RFQ NUMBER
 DEFK7044

ADDENDUM #01

ADDENDUM # 1

PROJECT: KINGWOOD READINESS CENTER
Camp Dawson
Kingwood, West Virginia

SHEET NUMBER:
SD-E-002

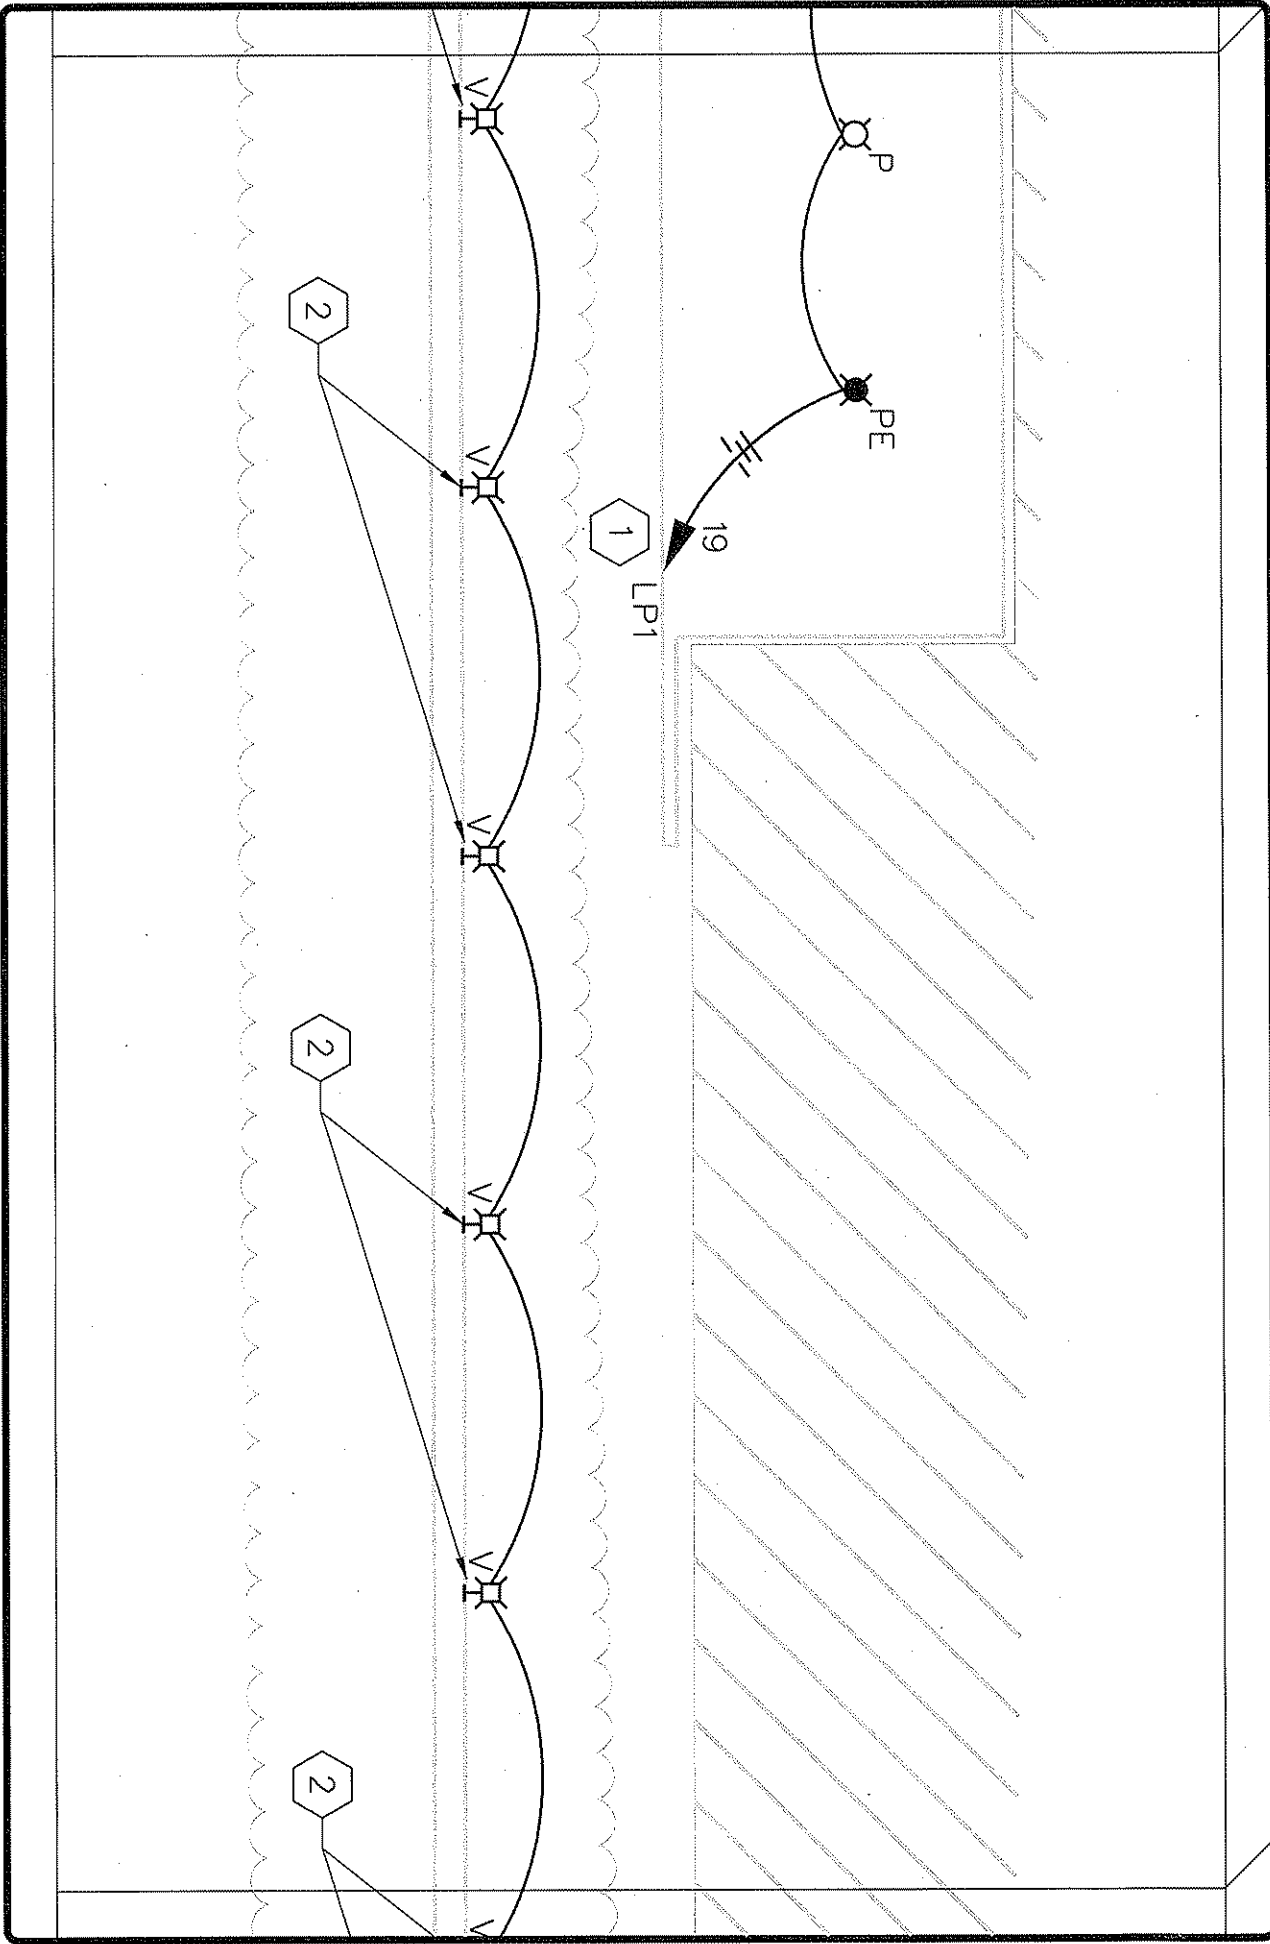
- 01-0046: M-503 HVAC DETAILS: Add Fire Damper Detail. Refer to supplemental drawing SD-M-002.
- 01-0047: ES-111 PARTIAL SITE PLAN - ELECTRICAL: add note to read "ALTERNATE: PROVIDE NEW STEPLIGHT FIXTURE. SEE LIGHTING FIXTURE SCHEDULE AND DETAILS ON SHEETS EL-501 THRU EL-504." Refer to supplemental drawings SD-E-001 thru SD-E-004.
